August 13, 2018

SUBJECT: Response to Comment #3 of the Department's July 12 and 23, 2018 Letters
New Hope Crushed Stone & Lime Company
Noncoal Permit No. 7974SM3
Solebury Township, Bucks County
EarthRes Project No.: 011012.015

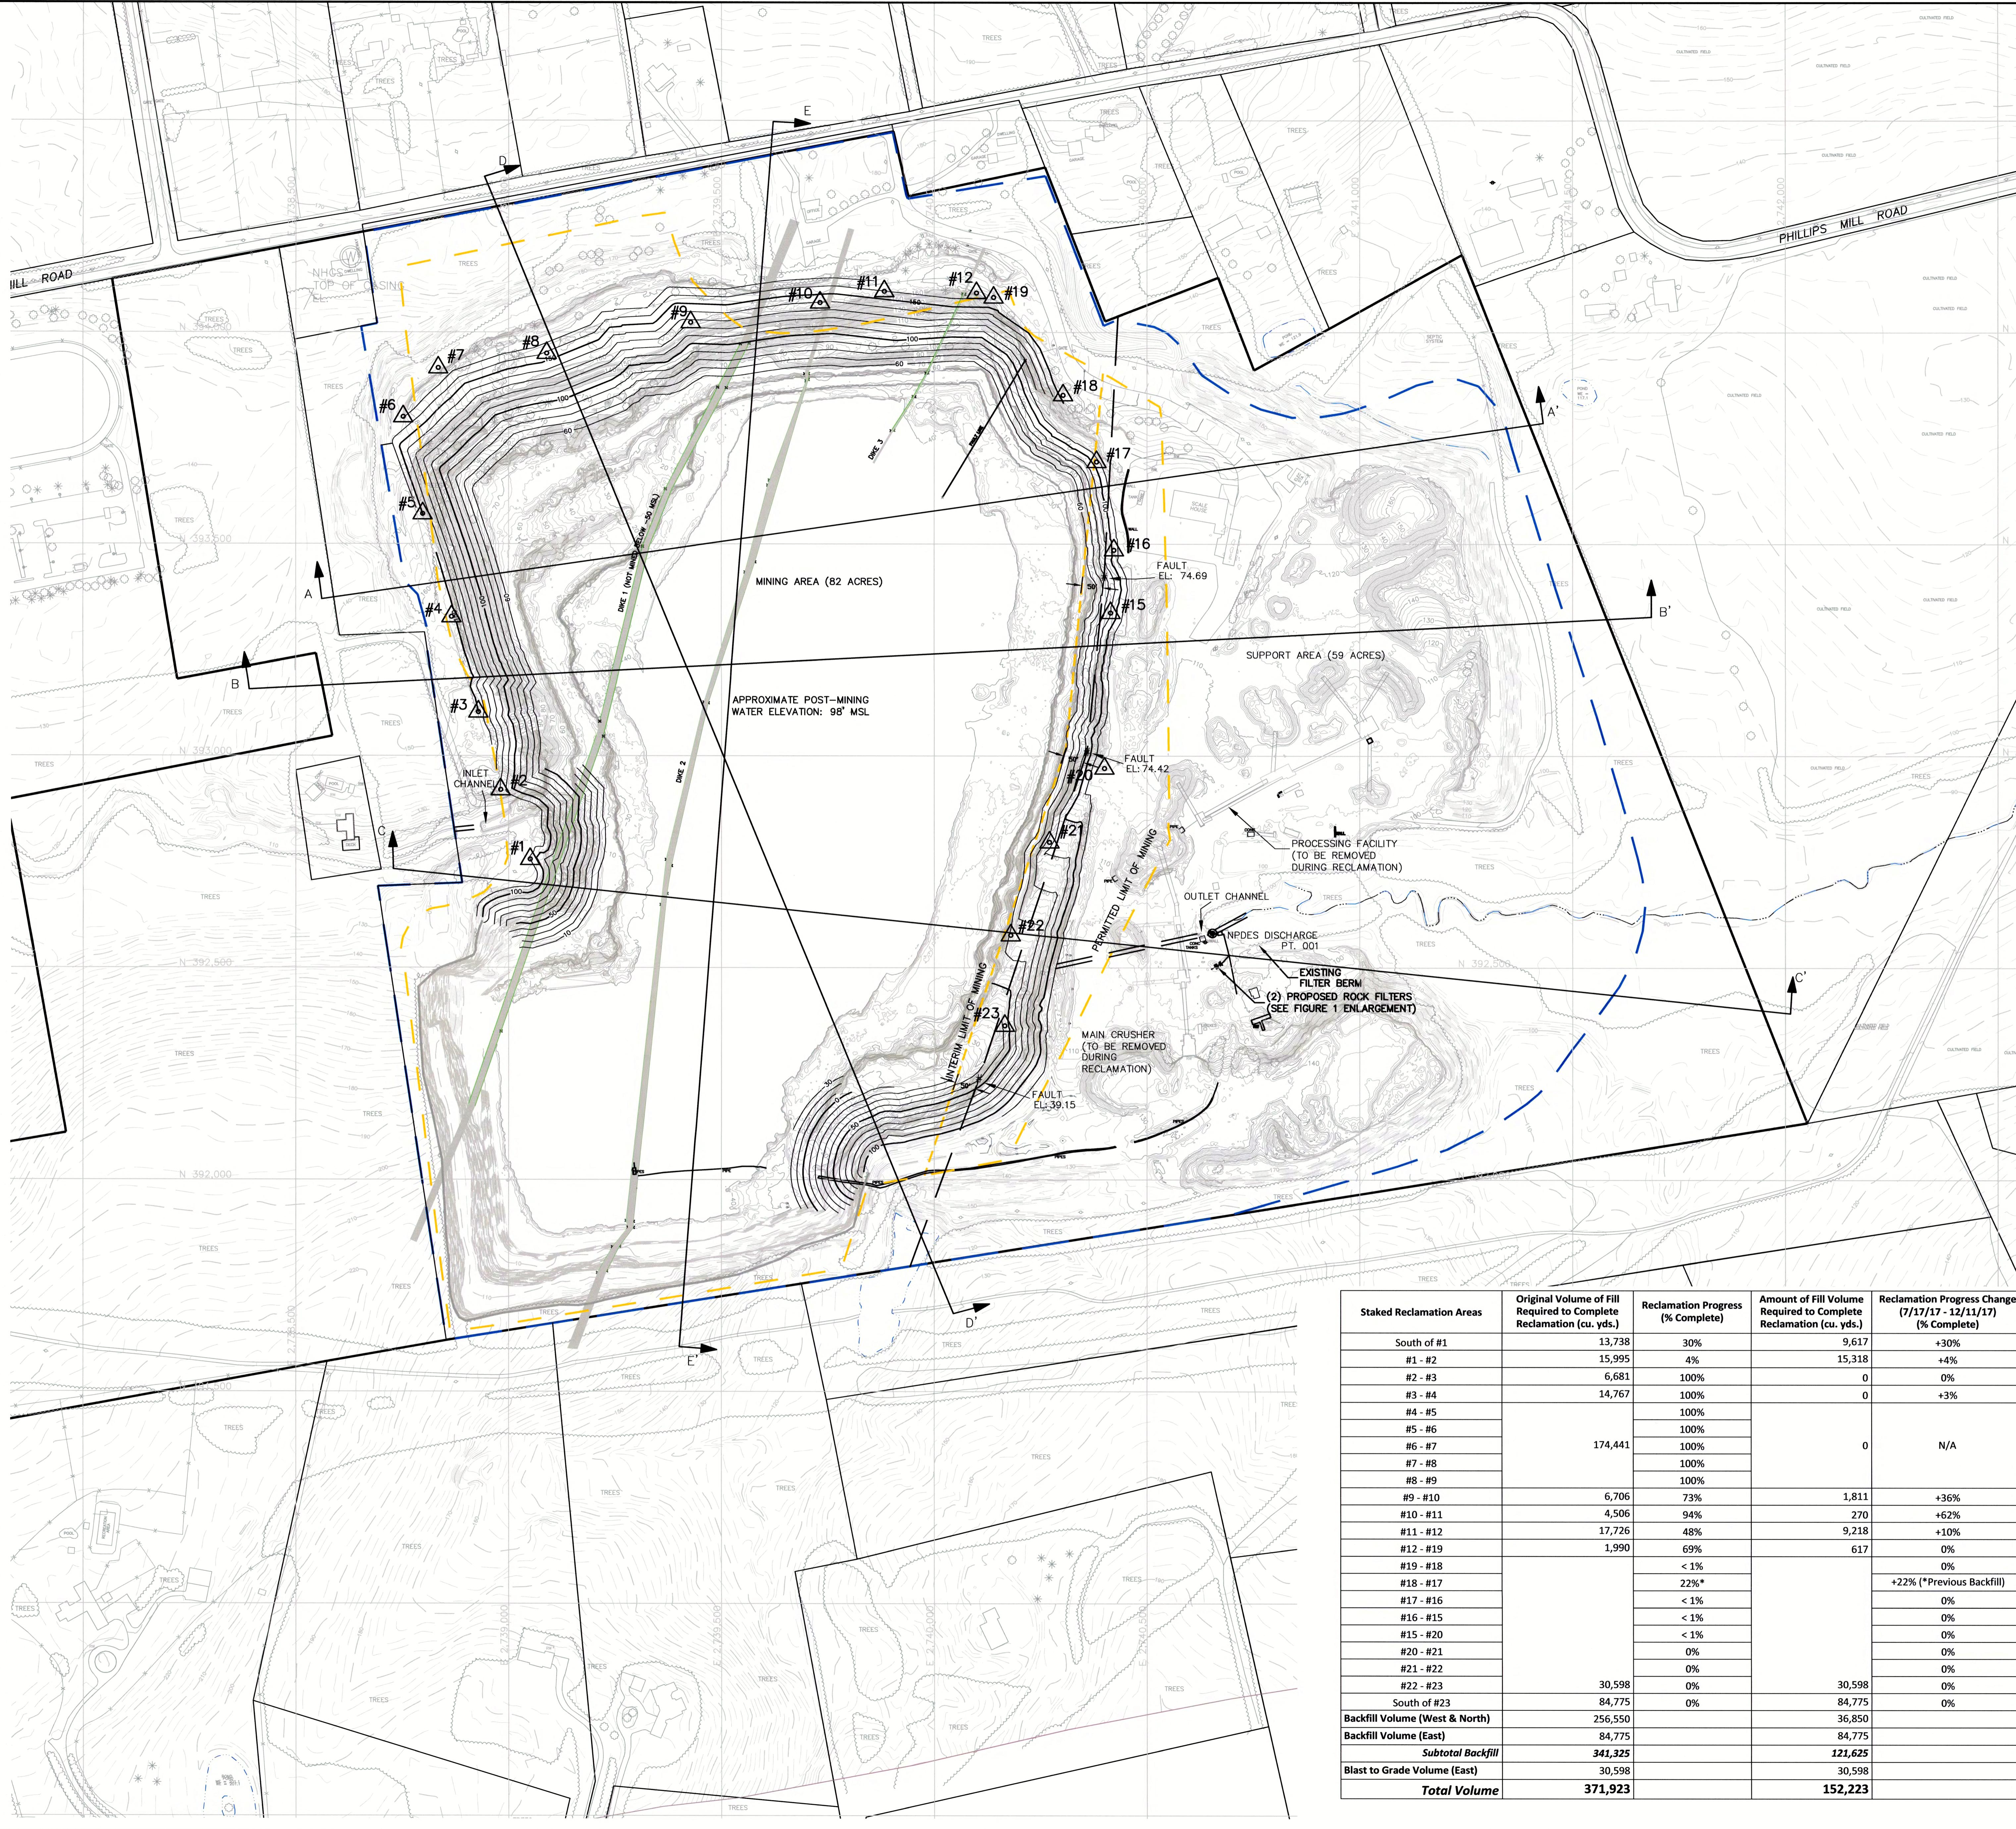
The "Reclamation Update Map" does not currently delineate the Furlong Fault Line or otherwise reference the blasting that will be utilized to achieve those slopes. New Hope shall provide a revised "Reclamation Update Map" that delineates the Furlong Fault Line and the associated Cross Sections. In addition, New Hope shall include the following wording as Note no. 3 on the revised "Reclamation Update Map": "Drilling and blasting will not impact the Furlong Fault in a manner that

The Reclamation Update Map has been revised to show the Furlong Fault as a dashed line drawn between the surveyed points shown on the previously submitted Reclamation Update Map (dated March 30, 2018). The projection of the fault has been added to the relevant cross-sections as requested (Sheets 1 of 3 and 2 of 3). Copies of the revised Reclamation Update Map and revised Cross-Section Sheets are attached.

As requested, Note No. 3 on the revised Reclamation Update Map states: “*Drilling and blasting will not impact the Furlong Fault in a manner that prevents NHCs from restoring the hydrologic balance to the permit-approved post mining water elevation.*”

Additionally, the fault was mined through decades ago along the southeast access ramp into the quarry. The elevation of the fault along the ramp, as shown on the attached Reclamation Update Map, is 39.15 feet mean sea level (MSL). The parties involved in the prior litigation viewed this specific area and other fault areas during a pre-trial quarry tour. Water was not observed coming through the fault into the quarry, in agreement with the 2010 Furlong Fault Groundwater Study Report. There have been no water level declines shown in nearby monitoring wells MW-1, MW-2, MW-4, and MW-8 from decades of mining. Water levels in these surrounding wells are approximately 90 to 100 feet MSL, much higher than the elevation at which the fault is breached. This result is due to the shale being a barrier to groundwater flow, the fault is simply the reason the shale is present.
